**Addendum No. 1**  
**City of Coquitlam**  
**Tender No. 78035**  
**Lougheed CPR Overpass Structural Rehabilitation**  
 (Consists of 2 Pages)

Issue Date: June 30, 2025

**Questions & Clarifications**

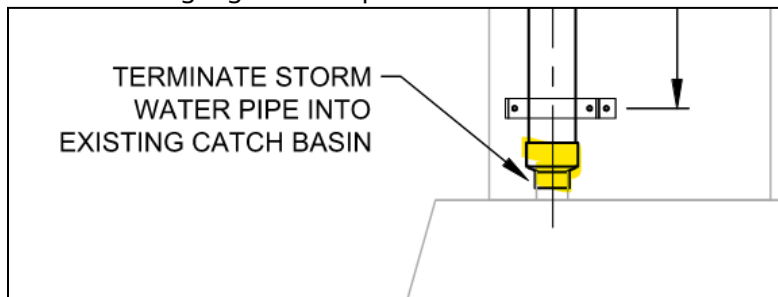
Q5) What is this highlighted component and is it included in the scope or existing?

**A5) The highlighted component is a new adapter termination/transition from the new PVC drain pipe to the existing catchbasin and shall be supplied and installed by the Contractor. Payment for supply and installation of this component is included in Pay Item 8.01 as listed in the Schedule of Quantities and Prices.**
